Service Alert

Subject: TRANSMISSION DESIGN CHANGE (PART SUPERSESSION)	Service Alert No.: SA-022/25
	Last Issued : 05/13/2025

2025 CX-70 H3T or PHEV

2024-2025 CX-90 H3T or PHEV

Original Design (Transmission Hole Drilled) (H3T shown, PHEV similar)

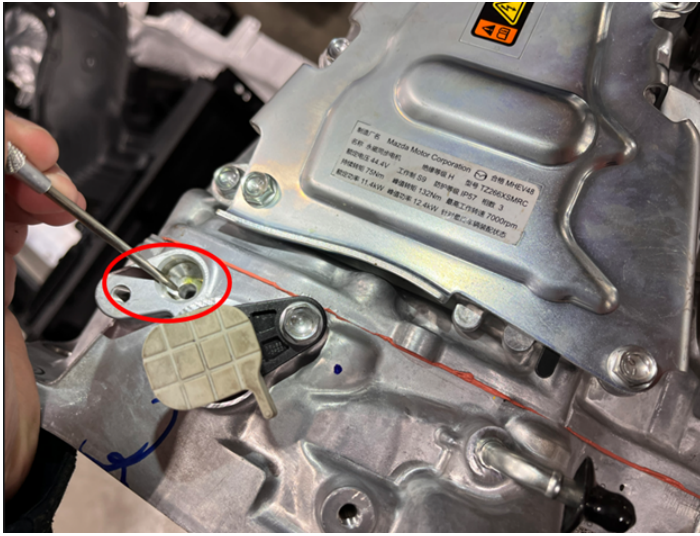
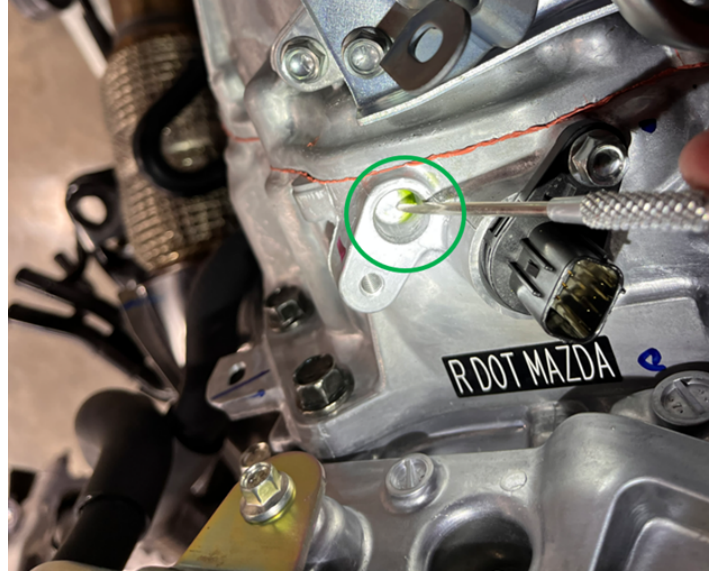
Old design originally required a coolant line running to the top of the bell housing, the new design has omitted the hole and need for the coolant line.

The new/superseded design can be used in place of the old/original design, and the coolant hose with fitting is no longer needed.
